Project Name: C.H. Four Commercial Park – Filing No. 1 – Final Plat

Date 10/23/01

## REVIEW SHEET SUMMARY

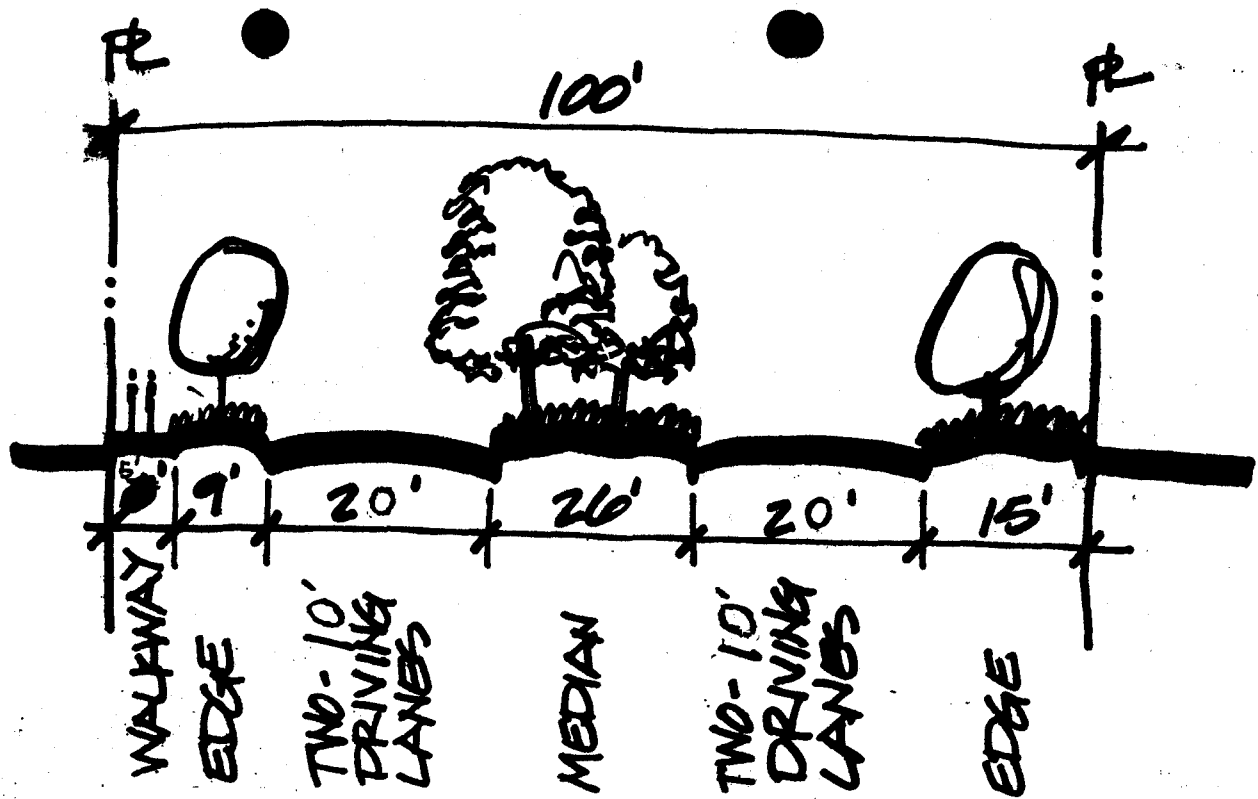
Filing 1: A left turn storage bay should be provided within the median on Hilaria Avenue at Horizon Drive. This will separate and facilitate left and right turn movements. Consideration should be given to provide left turn bays at all median openings, especially since the pavement is only 16' wide.

It seems to me that Hilaria Avenue should be made to align with at least one of the major driveways across Horizon Drive at the GSA complex. Does it? Intersections along H Road should be carefully coordinated with the Airport traffic circulation plan. I'm not sure how that one-way exit from the Airport will work opposite a "major entrance" to this development. It is also important to keep the sanitary sewers in dedicated streets. Will that "Loop Road" work for gravity sewers to serve all sites? Power of Attorney should be granted for full street improvements on both Horizon Drive and H Road. Based on the 100 Ft. right-of-way for Relocated H Road, shouldn't H Road half right-of-way be dedicated out to 50 Ft.? No utilities are shown for any area except Filing 1. If those dikes along Highline Canal aren't protected by easements, there is no assurance they will remain intact. The "ponding areas" shown on the Preliminary Drainage Plan don't mean much unless one knows what the site improvements will be and where they will be located. For all I know a building might be planned in a "ponding area". In summary, a drainage plan for raw land is not of much value when you know a lot of valuable improvements will end up on that land. Their proposed street section is not approved by this office. The asphalt mat should be 20 Ft. minimum wide on each side for a commercial area with on-street parking. Pedestrian facilities must be provided. With a 100 Ft. wide right-of-way, surely there is room for pedestrian facilities. The components of the City's adopted "Local Street in a Commercial Zone" apply to this street. Those 2 Ft. "V-Pans" are absolutely not acceptable on a city street. A 3 Ft. high berm with landscaping on top of it will have to be adjusted at driveways and intersections so as to not have sight-distance hazards. Vertical curves are to be provided at all vertical P.I.'s. I do not know if the grade on Horizon Drive will be lowered when it is improved. A financial guarantee in accordance with Development Regulations Section 27-2.3 should be obtained for all public improvements.

The applicant is willing to study further the alignment of Hilaria Avenue with respect to driveways across Horizon Drive into the GSA complex and will submit the change on the final plat.

According to the consulting engineer for the Airport Authority, the position shown for the access road is good, aligned directly across from the airport exit (see Walker Field response above).

The proposed 100 foot wide street cross section exceeds by 50% the City's adopted standard for "Local Street in a Commercial Zone" and is intended to provide a major development amenity. A high-quality commercial park of this type will provide adequate parking on each lot to satisfy the requirements of each use so that no on-street parking will be required. In the interest of creating a quality development, the applicant would request that all streets within the development be posted with "No Parking" signs. The applicant agrees to provide curb and gutter on both sides of the asphalt driving mat, and to adjust all earth berms and landscaping to provide proper sight distances. The applicant agrees with the need for a pedestrian facility through the development, but believes that sufficient pedestrian space can be provided on one side only of the roadway. The applicant proposes the alternative cross-section shown below:
